SUBJECT: **Safety Recall 12S37 - Supplement #2**
Certain 2001-2004 Model Year Escape Vehicles with 3.0L Engine and Speed Control Engine Cover Modification

REF: **Safety Recall 12S37- Supplement #1**
Dated August 22, 2012

Safety Recall 12S37 - Supplement #2
Certain 2001-2004 Model Year Escape Vehicles with 3.0L Engine and Speed Control
Engine Cover Modification

FIGURE 1

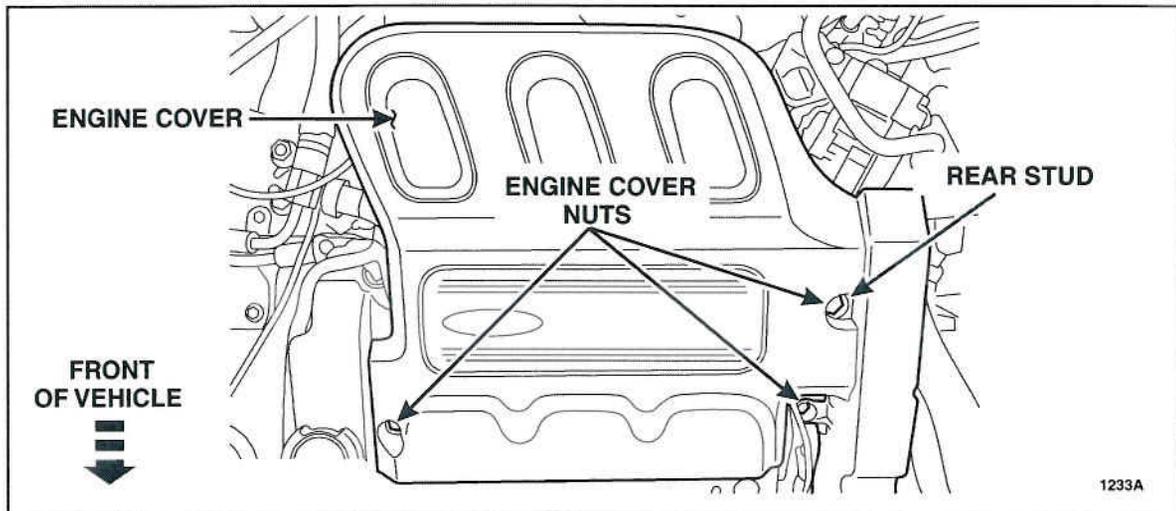
1. Remove the three nuts and the engine cover. See Figure 1.

- Reinstall the engine cover and tighten the three nuts. See Figure 1.
 - Tighten the engine cover nuts to 6 Nm (53 lb-in).
- Return the vehicle to the customer.

FIGURE 2

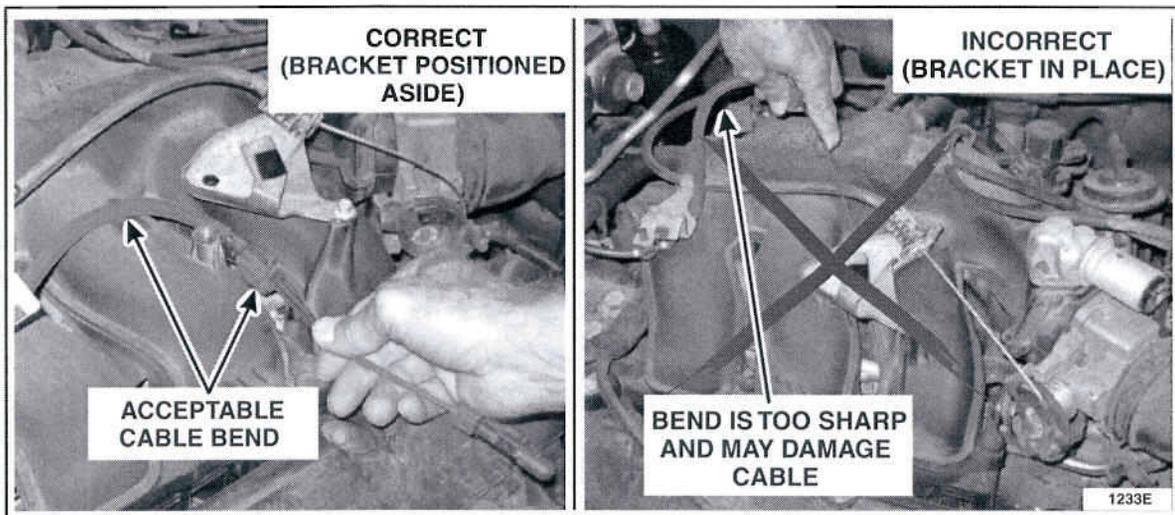
- If the speed control cable is connected, proceed to step 3.
- If the cable is disconnected, reconnect the speed control cable to the throttle body before proceeding to step 3. See Figure 2. To reconnect the cable:
 - a. Loosen the RH throttle cable bracket bolt and remove the LH cable bracket bolt.
 - b. Rotate the bracket to allow enough clearance for the speed control cable to be removed.
 - c. Remove the speed control cable from under the bracket and connect the cable to the throttle body.
 - d. Reposition the throttle cable bracket and tighten both bracket bolts to 10 Nm (89 lb-in).

FIGURE 3

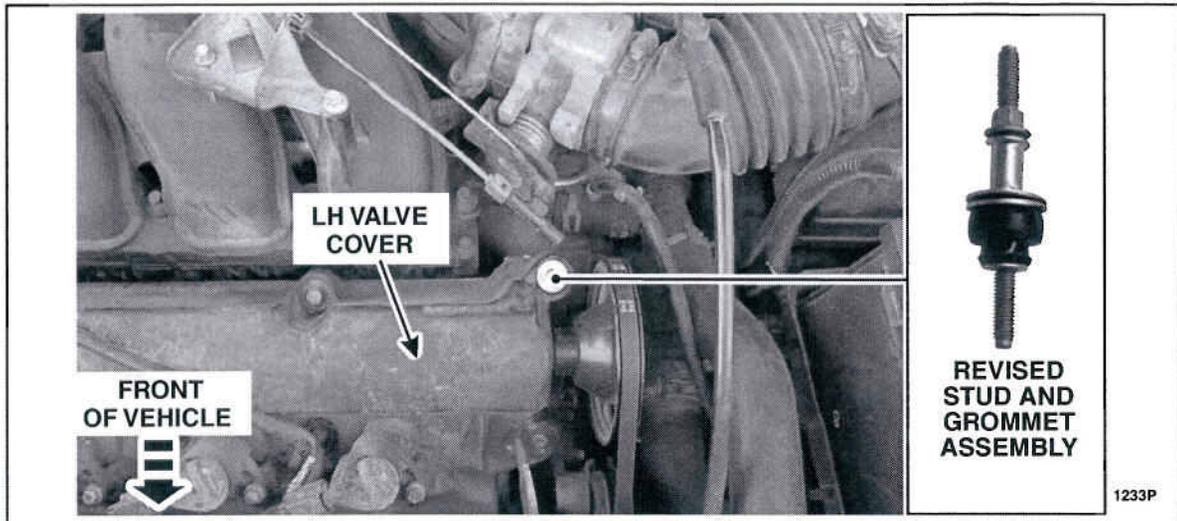
3. Remove the original rear stud and grommet assembly from the LH valve cover and install the *new* stud and grommet assembly. See Figure 3.

- Tighten the *new* stud and grommet assembly to 10 Nm (89 lb-in).

FIGURE 4

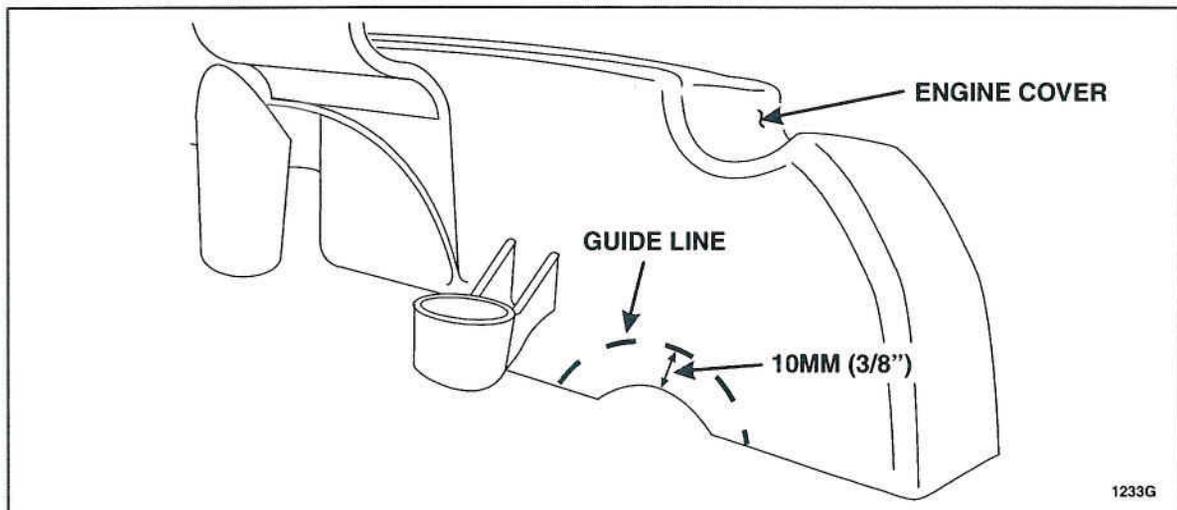
NOTE: The engine cover already has a relief to accommodate the drive belt tensioner. This relief needs to be trimmed to provide additional clearance.

4. Mark a guide line on the engine cover that is approximately 10mm (3/8") larger than the original opening. See Figure 4.

FIGURE 5

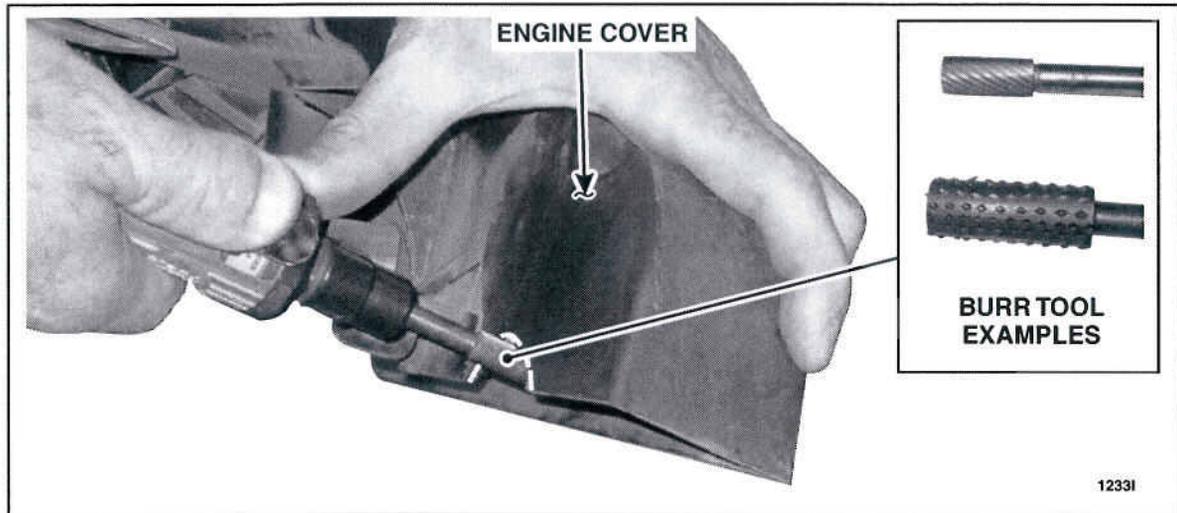
NOTE: Do not use hand tools or abrasive discs to cut the engine cover (hand tools will crack the engine cover and abrasive discs will melt the cover). Only high speed rotary burr tools should be used to modify the engine cover.

- Using a rotary burr tool, modify the engine cover by increasing the opening over the drive belt tensioner to the previously made guide line. See Figure 5.
